BROOKDALE AVE.,

BRIDGE NO. <sup>#</sup>10

FOUNDATION INVESTIGATION -- by  
Racey, MacCallum & Associates,  
Ltd.

Re: Intersection of Hwy. No. 401 and  
Brookdale Ave., Cornwall, Ontario.  
W.P. 103-59 -- District 9.

## SHEAR STRENGTH p.s.f.

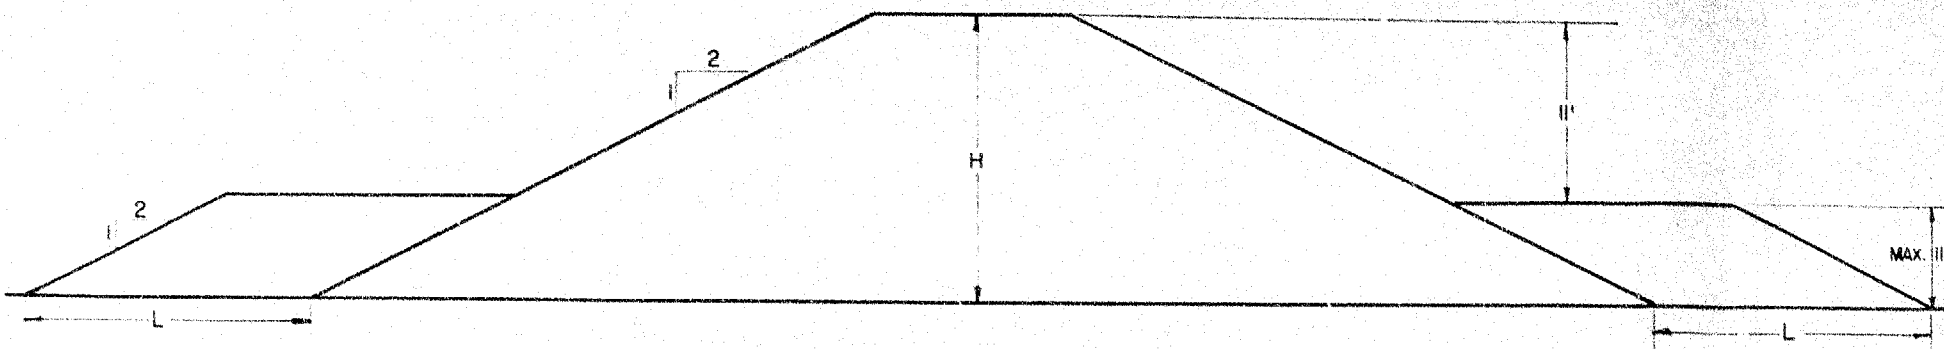
In reviewing the above mentioned report, we have found that the stability analyses carried out by the Consultant were not conclusive. We have also found that the interpretation of the shear strength values used in these calculations was not satisfactory. To accurately define the strength vs. depth profile, we have carried out one additional boring at the site; shear strength measurements were performed in the field and the laboratory. The results of these measurements have been summarized graphically and attached to this memo. From this shear strength presentation, it is obvious that too high values have been used in the previous stability investigations and we have, therefore, carried out additional analyses based on the following assumptions:-

RECOMMENDED BERM SECTION

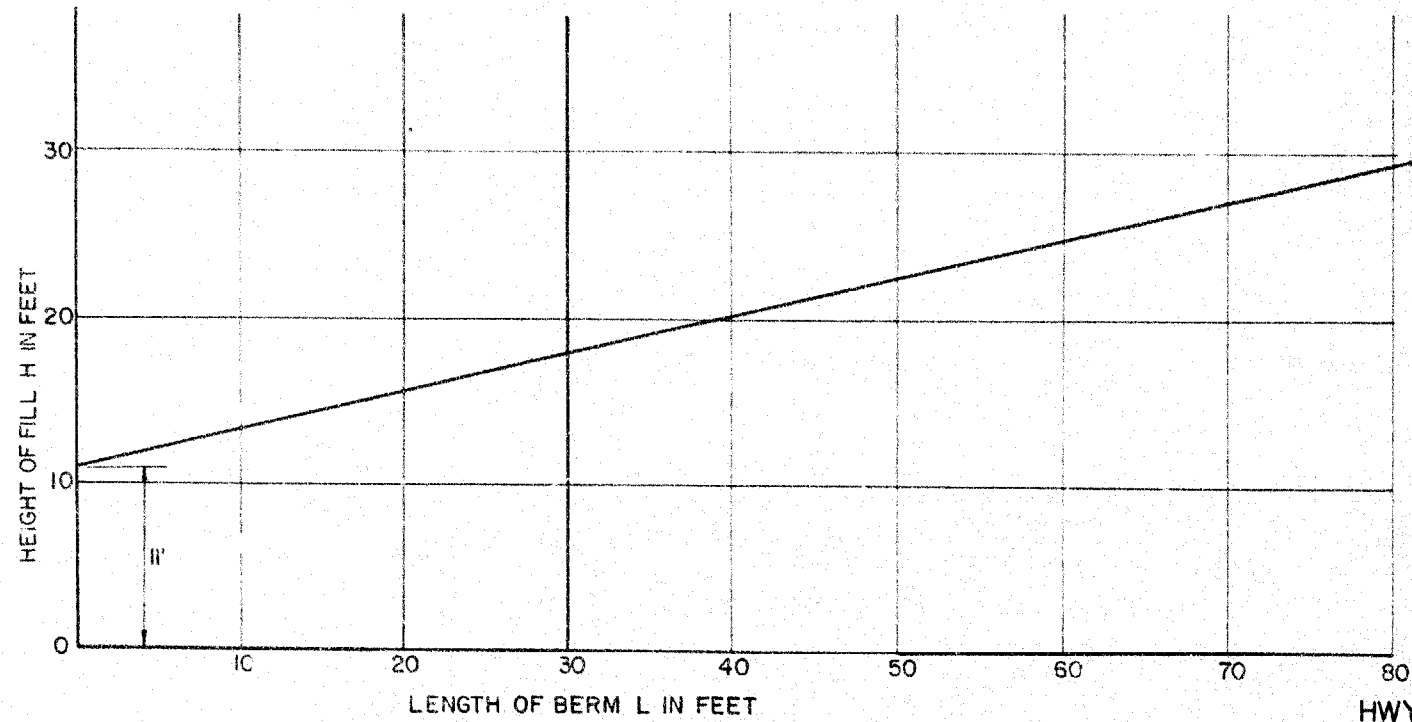
Stability calculations have shown that counterbalancing berms are required for the fill height of 22 ft., proposed. The maximum safe height of the fill that can be built without a berm, is 11 ft. The required length of berm is given on the attached graph giving the relationship between the height of fill to the length of berm. The berm slope is also 2:1. The berm will have to be built in a direction parallel to road centre line, as well as at rightangle to centre line. The structure will have to be founded on end-bearing, small displacement type piles, driven to the contact of the limestone bedrock formation.

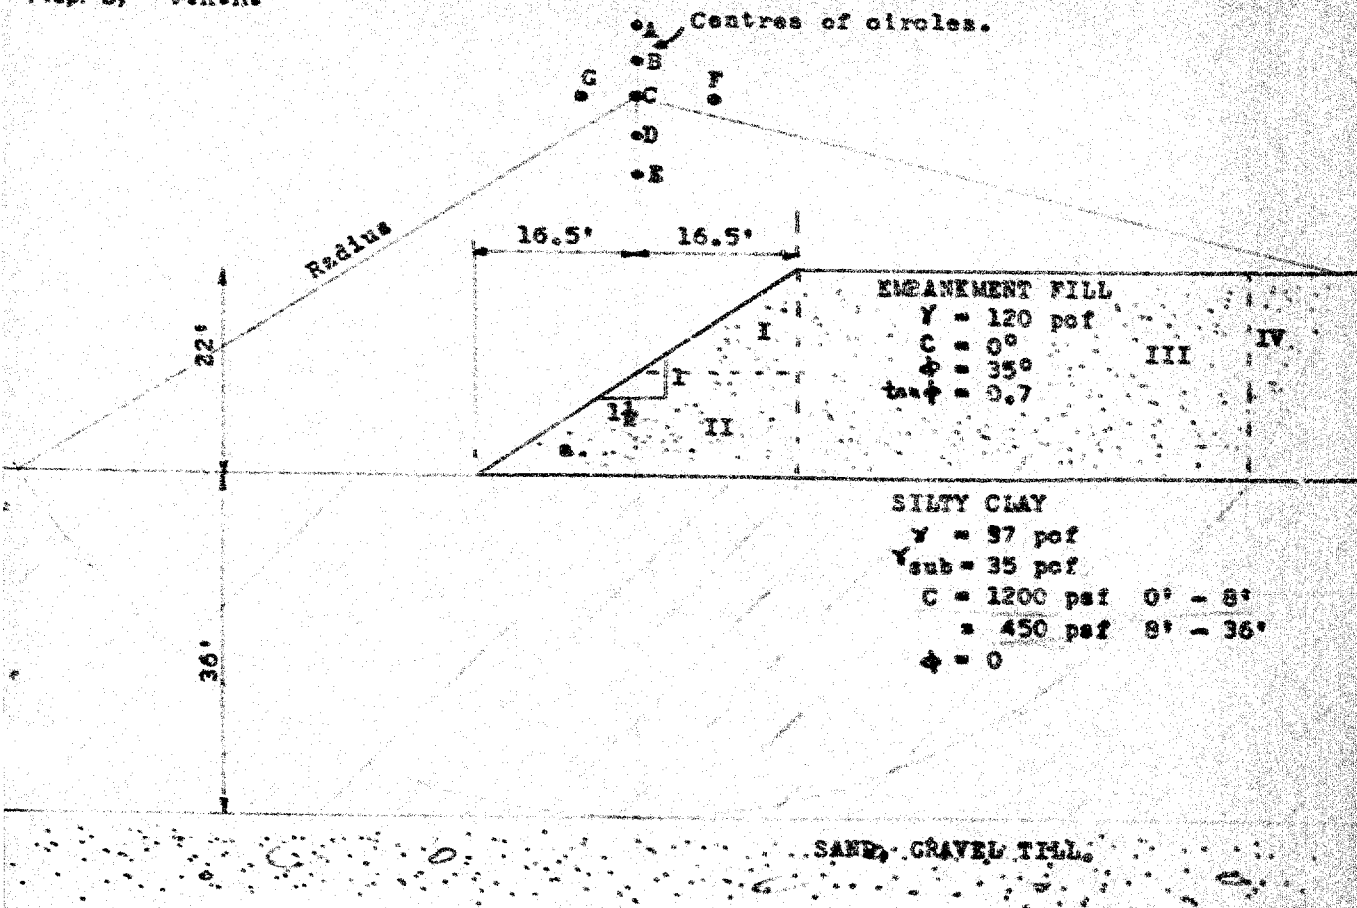
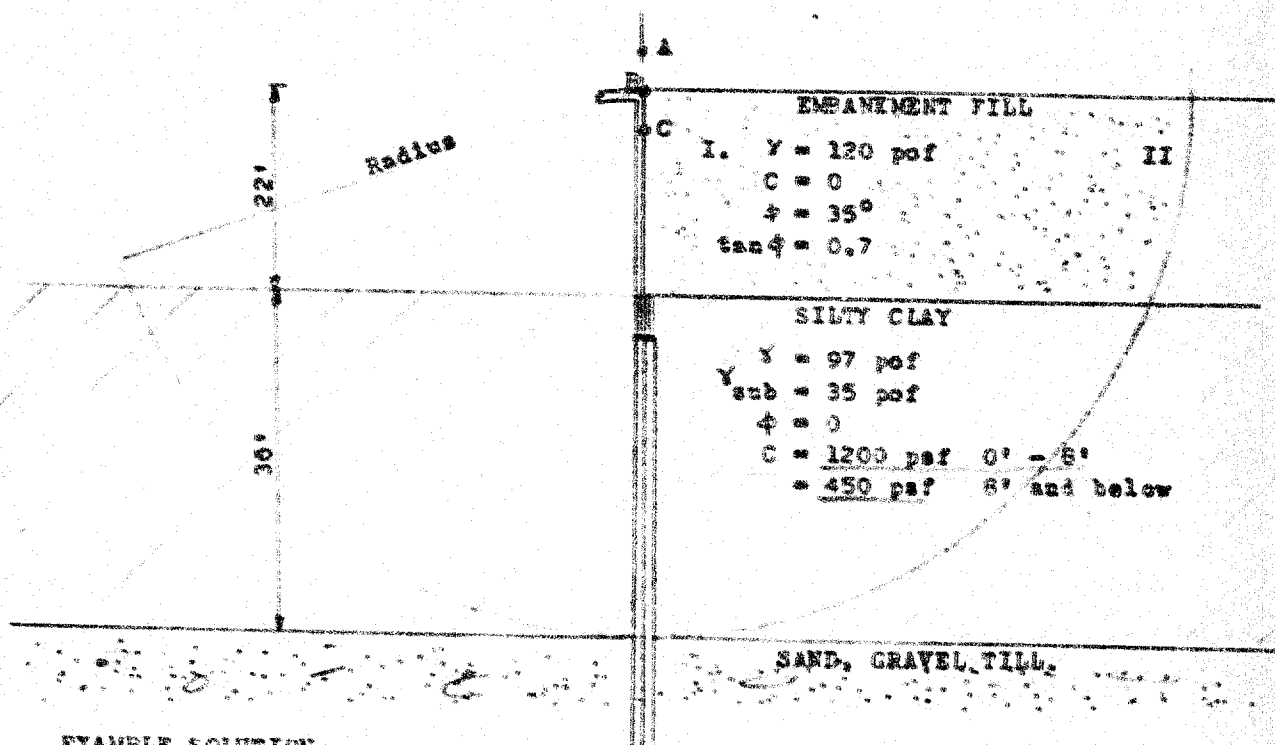
Height of fill equals 22 ft.; shear strength of the clay subsoil  $c = 350$  p.s.f. Because of the very limited depth of the upper stiff layer (approx. 7 ft.) the increase of shear strength has been neglected. The embankment slope was taken as 2:1.
